145.2.8.6 Output current during power up

Page 161 Line 40

Figure 145–23— $I_{Inrush-2P}$ and I_{Inrush} current and timing limits, per pairset in POWER_UP state

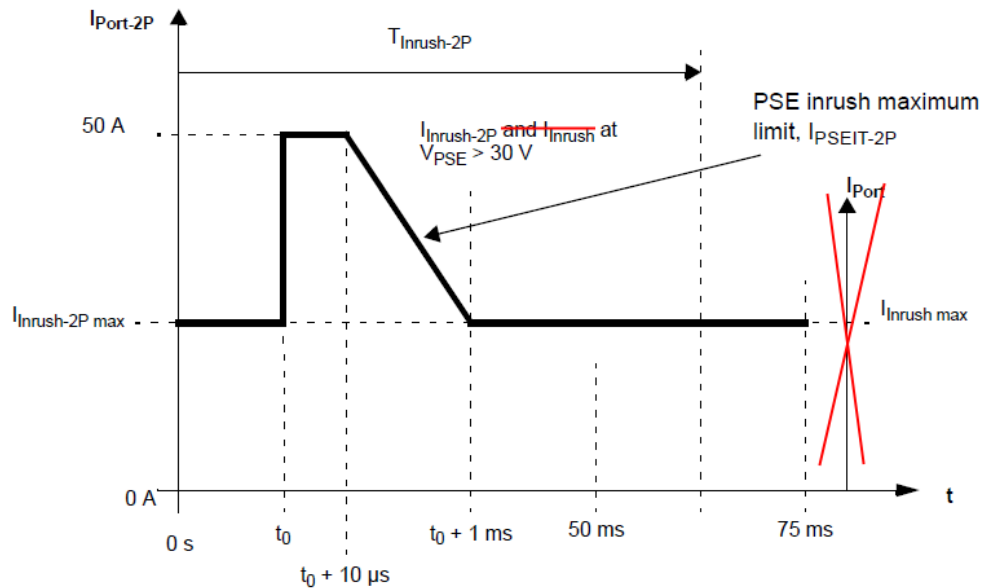
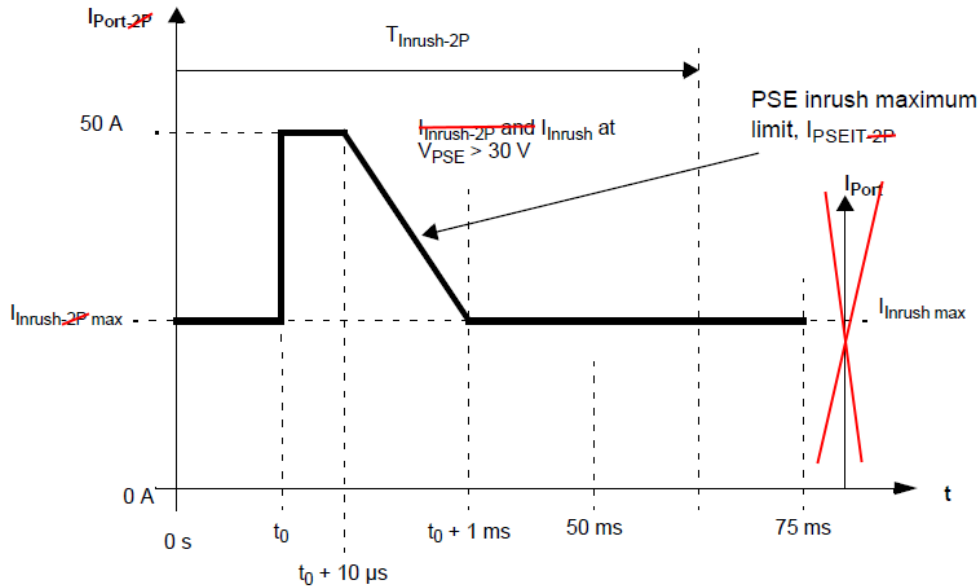
First specify $I_{Inrush-2P}$ then I_{Inrush}

Append following text for I_{Inrush}

The PSE shall limit ~~$I_{Inrush-2P}$ and I_{Inrush}~~ during POWER_UP per the requirements of Table 145-16. The maximum inrush current sourced by the PSE ~~per pairset~~ shall not exceed the ~~per pairset~~ inrush template in Figure 145-XX and Equation (145-YY). The PSE inrush maximum limit, $I_{PSEIT-2P}$, is defined by the following segments:

Figure 145-23— ~~$I_{Inrush-2P}$ and I_{Inrush}~~ current and timing limits, ~~per pairset~~ in POWER_UP state

- t is the time in seconds
- ~~I_{Inrush}~~ $I_{Inrush-2P}$ is the maximum value of ~~$I_{Inrush-2P}$ or I_{Inrush}~~ as defined in Table 145-16
- t_0 is the time when $I_{Port,2P}$ exceeds ~~$I_{Inrush-2P}$ max~~ for the first time during POWER_UP. The range for t_0 is $0 \leq t_0 \leq 49$ ms.
